Mike Nugent - 44 Federal Street

From: Mike Nugent
To: Mark Chaloupecky
Subject: 44 Federal Street

The following are our responses to your plan review for the above referenced project, as discussed by telephone on 8-26-05:

RE: 44 Federal Street - Site Plan and Subdivision Application
App ID# 2005-0019, CBL #20-D-11

1 Hour Rim Board Assembly

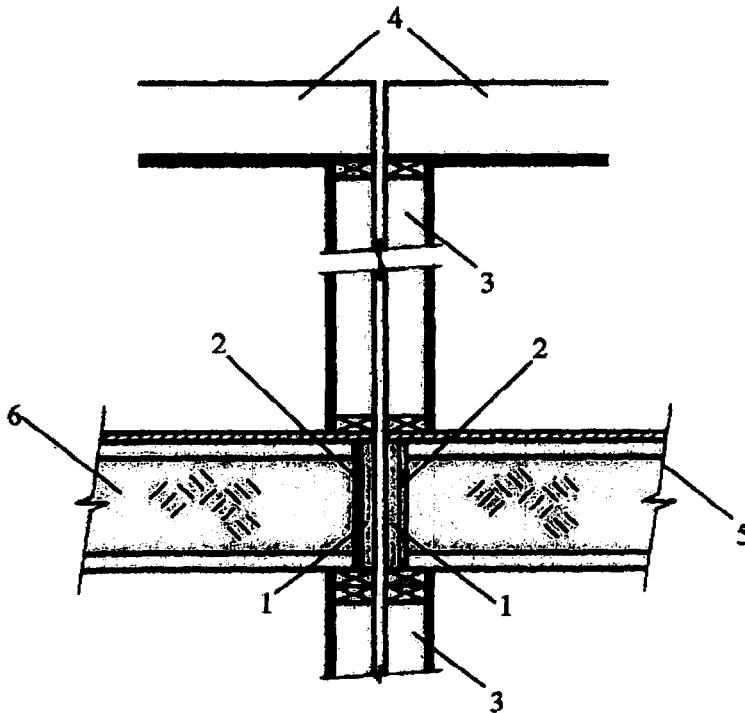
* In lieu of rating the Floor / Ceiling System, can we install 5/8" Type "X" gyp. bd. in the location shown, to maintain the 1-hour rating between condominium units. (It would be a contractor's option).

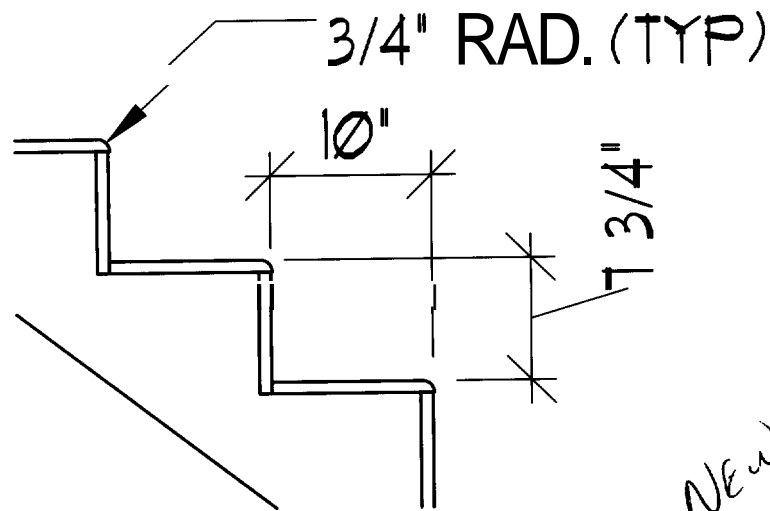
I already provided comment on the Special Inspections and The Fire separation assembly/party walls.

1. The party walls between condominium units are designed for UL #341. We have updated the wall detail at the floor / ceiling level to provide for continuous fire protection between units. See attached detail.

STAIR NOSING DETAIL

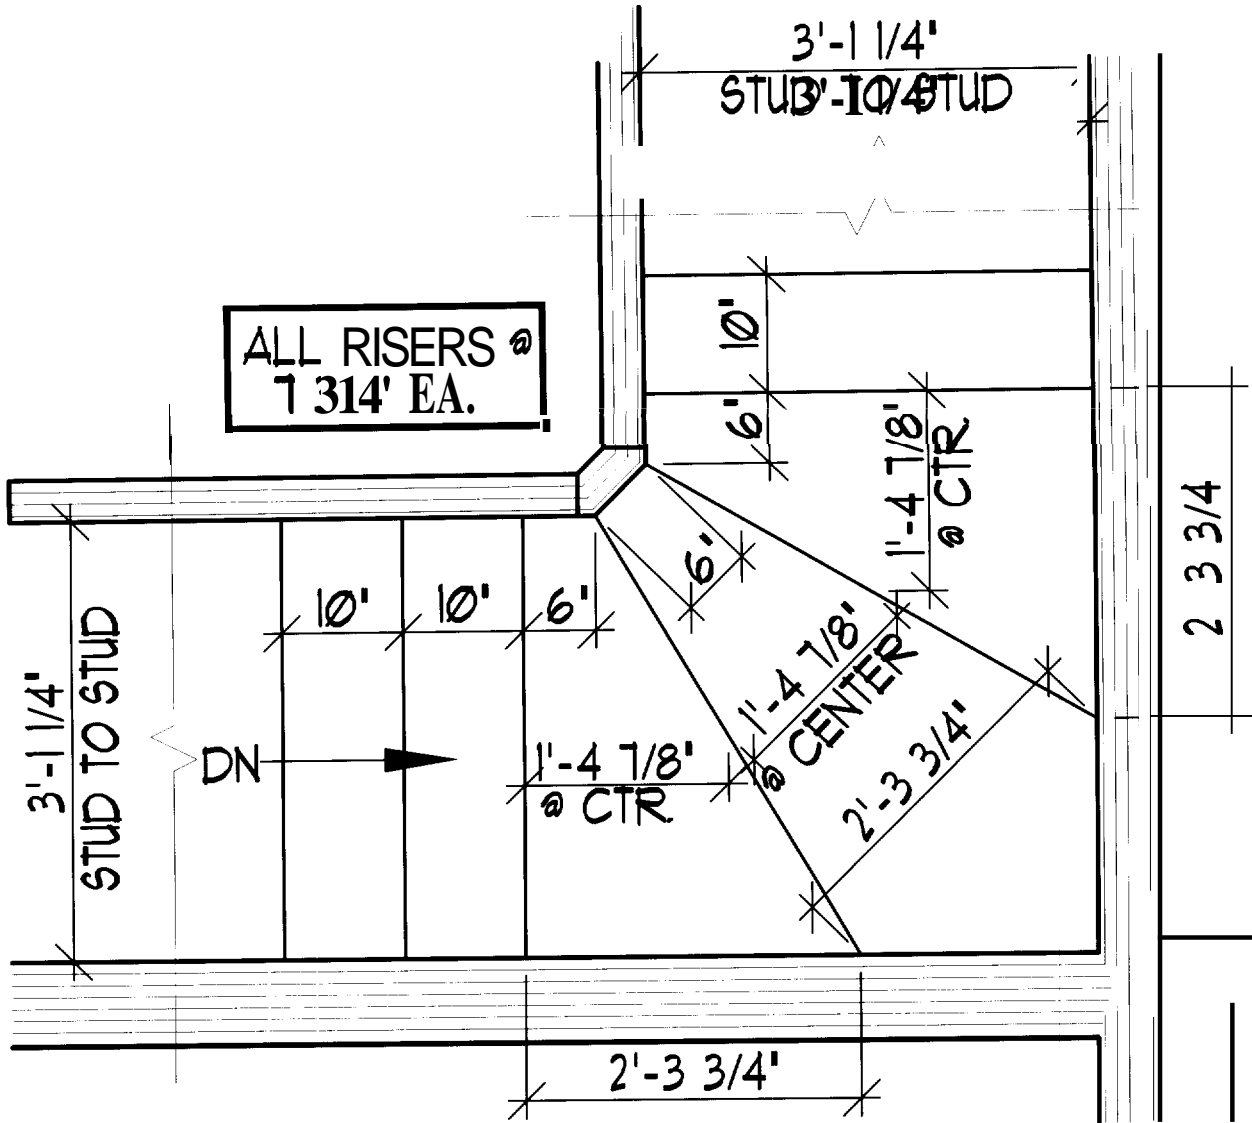
- 4) Nosing are not shown on the stairs, but are required for the R3 10 inch tread.
- 5) Please provide a riser dimension, I assume it's 7.75 like on the winder detail.

NEW
PLAN
WILL
SHOW
3/4" NOSING
CMB

4. A ¾" nosing will be added to the stair profile per Section 1009.3 (Exception #5) of IBC 2003. Refer to added detail 3, Sheet A4 (also attached).
5. Riser dimensions are 7 ¾" and are shown on each set of stairs on Details 1 and 2, Sheet A5.2.
